PCN
**New supplier and correction of dimensional tolerance
for EPCOS PM coil formers**

190118FER1e

Product / Process Change Notification

1. ID No. MAG-546100119		2. Date of announcement January 18, 2019	
3. Product / product group PM coil formers PM 50/39 PM 62/49 PM 74/59 PM 87/70	Old ordering code B65647B1014T001 B65685A1000T001 B65685B1016T001 B65687A1000T001 B65687A1018T001 B65714J1000T001 B65714K1020T001	New ordering code No change	Customer part number No change

New dimension 44.0 mm max:

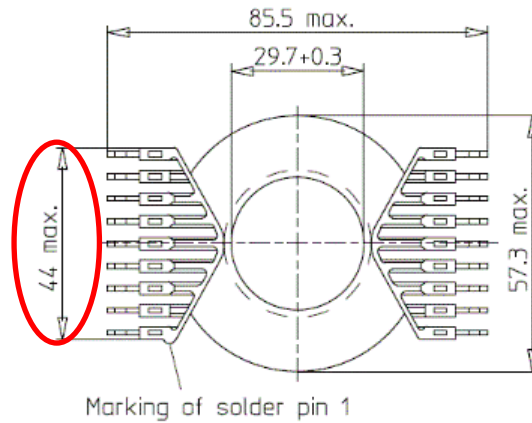
4. Description of change Change of supplier for named coil formers made of VALOX 420SE0 material. Transfer of existing tools for given items. In parallel correction of datasheet: tolerance for PM 74/59 coil formers (B65687A1000T001, B65687A1018T001) dimension 43.4 mm max. to 44.0mm max. in accordance with dimensions of finished products.
